STAFF REPORT: 09-10-25 REGULAR MEETING

APPLICATION NUMBER: HDC2025-00545

ADDRESS: 630 VIRGINIA PARK

SCOPE: ERECT CARRIAGE HOUSE

From applicant's submission: Proposed site plan at left (not to scale). At right, renderings of front (yard-facing) view, top, and rear (alley-facing) view, bottom.

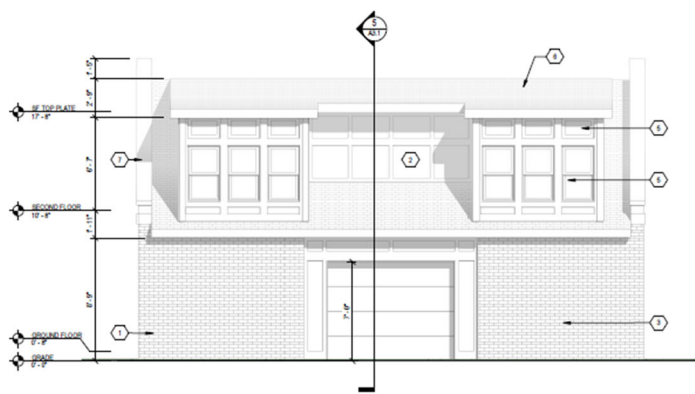
Staff response: The state of being “ornate,” if applicable at all to a new accessory building, prioritizes intricate shapes and complex patterns. Despite its contemporary design, the carriage house achieves a modern “ornateness” that staff finds too “busy” with respect to the main house on this property. Referencing the main house, half-timbering is limited to the front of gables, both at the porch and at the roof. The proposed carriage house uses a much higher proportion of half-timbering, cladding all parts of the dormers and even some 1st-story areas. Staff recommends that the yard-facing gabled entry should eliminate the half-timbering to grade in favor of brick, keeping the detailing at the gable above only. The same is true for the 1st-story half-timbered “frame” at the alley overhead door. At the upper level, staff recommends elimination of the half-timbering panels on the sides and between dormers, in favor of a less complex panel expression painted in a darker color.

- Per the above analysis, staff finds that the contemporary design of the building, in a modern reinterpretation of Tudor, conforms to the Elements and is compatible with the historic character of the existing resource, excepting the use of half-timbering as a dominant cladding material, rather than an accent.

- The design should be revised to eliminate half-timbering panels to remain deferent to, and less complex than, the main historic house at the property. All half-timbered areas should be replaced with brick at the 1st story, and dormer returns and other recessed areas should be replaced with simpler panels at the upper level, painted a darker/recessive color.

From applicant's submission: Elevations (not to scale). Refer to submitted drawings for full architectural drawings under review.

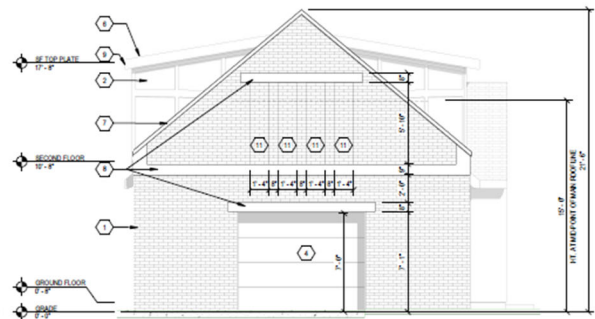
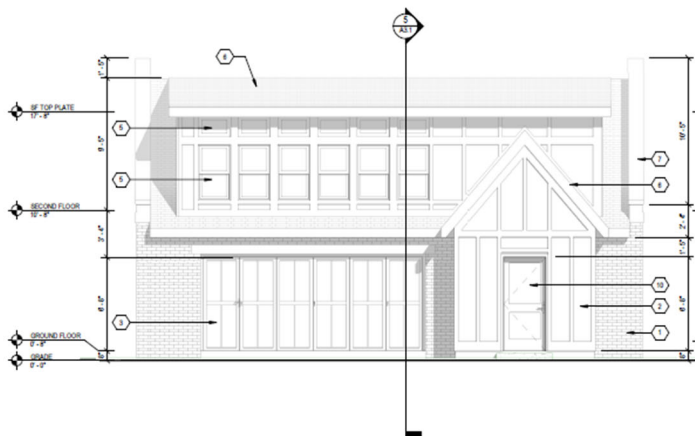
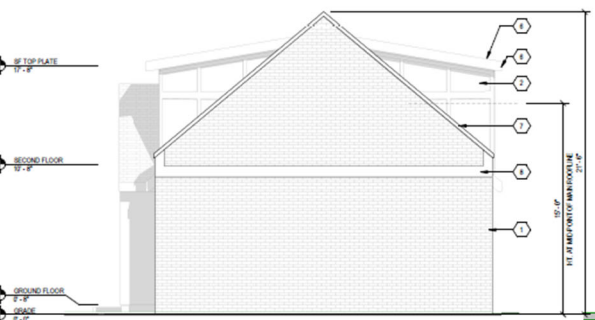
Staff response: While the proportion of openings within the yard-facing side of the carriage house is high, it is not out-of-character for a garage, the above guidance being based on houses.

Staff response: The proposal displays textural interest compatible with its context and its contemporary design, but uses half-timbering as a primary cladding instead of an accent, like the house.

Staff recommends that the proposal for a new garage/carriage house building at 630 Virginia Park should qualify for a Certificate of Appropriateness, as it meets the Secretary of the Interior's Standards and the New Center Area's Historic District's Elements of Design, with the condition that the design be revised to reduce its complexity/competition with the main house, by:

- Eliminating half-timbering panels at the first story, in favor of additional brick p
- Reducing the extent of half-timbering panels at the upper level, while introducing panels/cladding with less complexity rendered in a darker color.
